RE: Response to Comments
Mary River Project – 2018 Work Plan - Modification Request No. 7
Type 'A' Water Licence - 2AM-MRY1325 - Amend. No. 1

Table 1 - Baffinland Responses to Comments
Modification Request No. 7, Type A Water Licence 2AM-MRY1325

Figure 7-3. Arctic char distribution in waterbodies in the Milne Port Area.

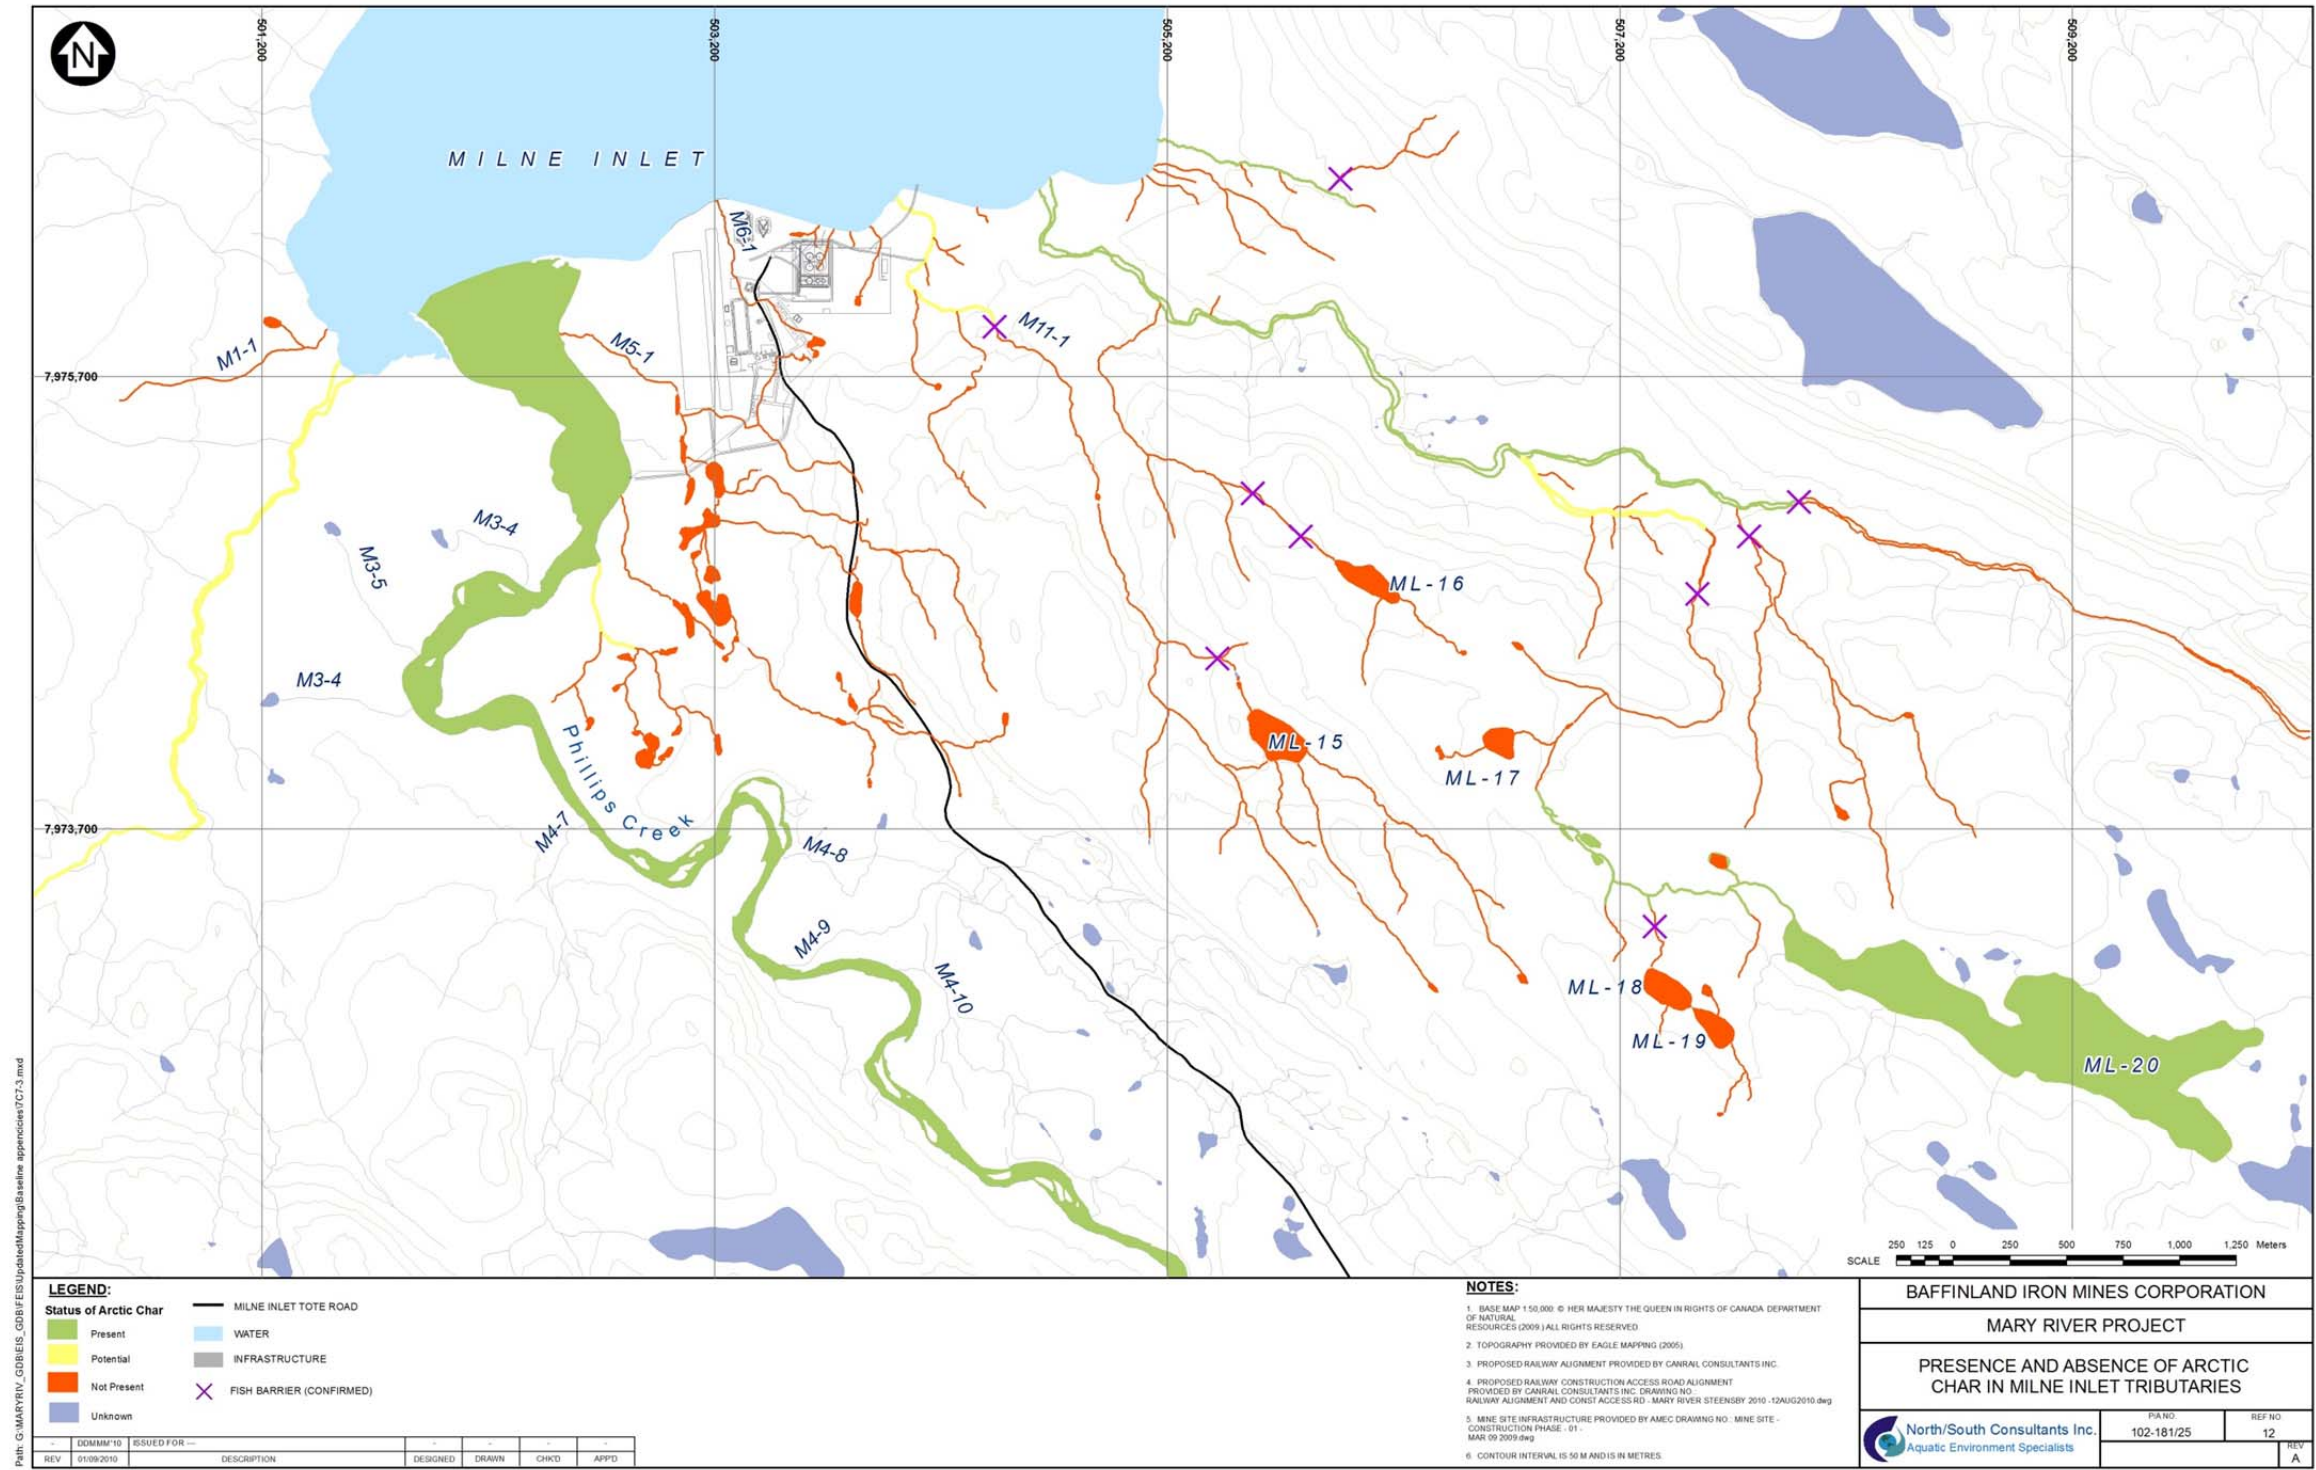
DFO		
1	<p>DFO-FPP notes in Table 2 of 2AM-MRY1325 Project Modification Request No7 Part 1of 6, under Freshwater Aquatic Environment on page 5, it states: "None of the proposed modifications are situated within or immediately upstream of fish habitat." DFO-FPP further notes in section 3.1.3: Identification of any Potential Impacts to Receiving Environment on page 9, it states: "Ponded water will be displaced and drainages will be rerouted; none of the ponds or drainages are fish-bearing but eventually report to Phillips Creek which is fish-bearing" and section 3.4.3: Identification of any Potential Impacts to Receiving Environment (page 14) further states "...drainages will be rerouted consistent with the Milne Port Water Management works detailed in Section 3.5; none of the ponds or drainages are fish-bearing but eventually report to Phillips Creek which is fish-bearing during open water."</p> <p>The Milne Port laydown area modifications have the potential to cause negative impacts to fish and fish habitat for several of the ponds that are proposed to be modified under Modification No. 7. DFO-FPP notes that Baffinland has stated that "none of the ponds or drainages are fish-bearing", however DFO-FPP also notes that limited baseline information has been provided to support this conclusion. DFO-FPP is unclear what information, baseline data/ studies were used to inform the non-fish bearing status of the ponds and drainages. In the absence of adequate baseline surveys conducted for each of the ponds and drainages affected by the modification proposal, DFO-FPP is unable to adequately assess Baffinland's conclusions of impacts.</p> <p>However, should the noted ponds be determined to be fish bearing, DFO-FPP would require Baffinland to submit a 'Request for Review' prior to construction of the laydown areas.</p> <p>Therefore, DFO-FPP recommends Baffinland provide baseline data and associated rationale to support Baffinland's conclusion that the impacted ponds are non-fish bearing.</p>	<p>See above response to CIRNAC concern. Baseline information was provided in the FEIS Appendix 7C "Freshwater Aquatic Biota and Habitat Baseline Synthesis Report 2005-2011" (North/South Consultants, January 2012). Figure 7-3 from this report (appended), demonstrates the identified fish bearing waters in the Milne Inlet area, and as can be seen the ponds/watercourses in question have been identified as not fish bearing.</p>
